Report from the EqOP IWG Workshop No 1 (whiplash/rear-end) at BAST.

September 5-6, 2023.

Technical workshop with two different seats and various ATDs

Seat A received "good" rating in the 2011 Euro NCAP rear impact test.

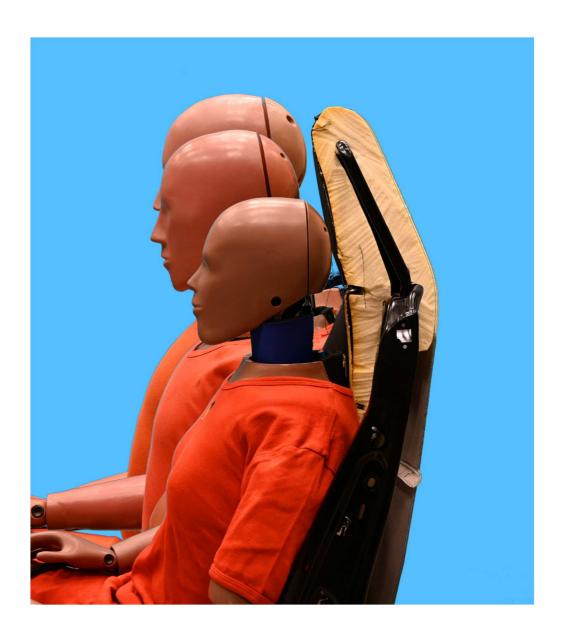
- Integrated head restraint with soft foam (compared to Seat A), underlying head rest structure optimised towards the centre of gravity of the dummy's head ("BioRID Catcher")
- Without the possibility to adjust the height of the head restraint and the underlying structure, the injury risk potential increases to all occupants, both shorter and taller than the BioRID.

Seat B (received "marginal" rating in the 2022 Euro NCAP test)

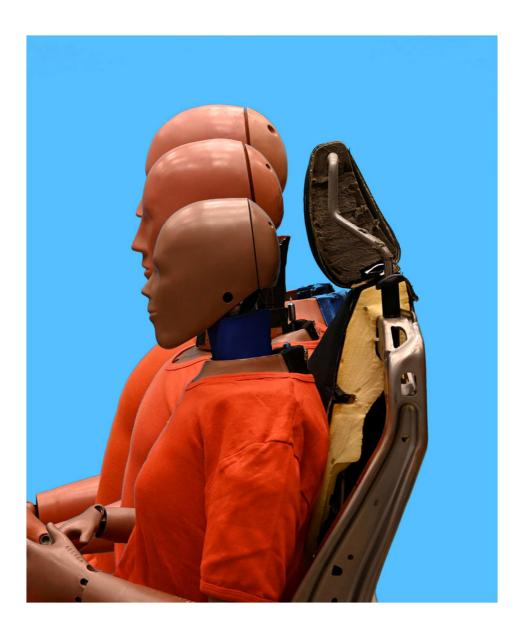
- Height-adjustable head rest with stiffer foam (compared to Seat A), underlying head rest structure consisting of metal bracket.
- The height adjustable head restraint can be seen as an improvement compared to the design of Seat A and should potentially reduce the risk of injury (if the head restraint is set to the correct height). However, especially for smaller occupants, the head restraint cannot be optimally adjusted.
